MEMORANDUM

From:	Duncan Fisher Ecology Officer		
Service	WBC Ecology	App No:	242665
Address:	Land west of Kingfisher Grove, Three Mile Cross.		
Proposal:	Application for approval of Reserved Matters pursuant to Outline Planning Consent 201002 (approved under appeal ref. APP/X0360/W/22/3304042 dated 31/01/2023) for the erection of 49 no. affordable dwellings with associated drainage and attenuation, open space and landscaping. Details of appearance, landscaping, layout and scale to be considered, plus details for discharge of conditions 11, 12, 13, 15 and 16 from the Outline permission.		
Type of Development:	Major Dwellings (10+)		
Site Visit Made:	Yes/No

Reserved Matters

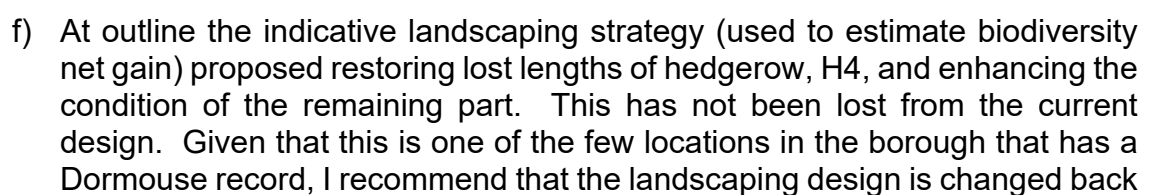
- a) The boundary treatment behind plots 1 to 8 is proposed as close board fence. The gap between these gardens and the edge of the site is proposed to be mixed scrub habitat that will need to be maintained in order to achieve biodiversity net gain. I am concerned that the type of boundary treatment proposed is prone to being moved and there may be garden encroachment and loss of this important corridor. I recommend that the boundary treatment should be changed to brick wall to mitigate this risk.

- b) The Levels Strategy and Cross-section B indicates that there will be step level changes between plots – e.g. 1.35m between plots 14 and 15 – it is not clear whether there will be retaining walls used at boundary fences between plots. This needs to be clarified so the development can show how it provides ecological permeability between rear gardens and between the gardens and public open spaces.
- c) Regarding ecological permeability, the plans need to show where the Hedgehog Highway holes (as per MM10 of the Updated Ecological Appraisal) will be installed within boundary treatments.
- d) Within the soft landscaping plans, it would be preferable to remove the six trees proposed for the southern and western edges of the wildlife pond in order to prevent the pond being too shady.

- e) It is not appropriate to plant new trees so close to retained powerlines (it appears that no easement has been accounted for). They will not be sustainable in these locations in the medium to long-term. These trees should be moved to locations where they will have sufficient growing space without interference with the powerlines.

to restore the length of the hedgerow and provide connectivity for this species.

It may be that the detail to resolve these points can be resolved during discharge of condition 7, which I understand will be subject to a separate application. However, it is preferable to ensure that there isn't a confusing picture of contradicting approved plans.
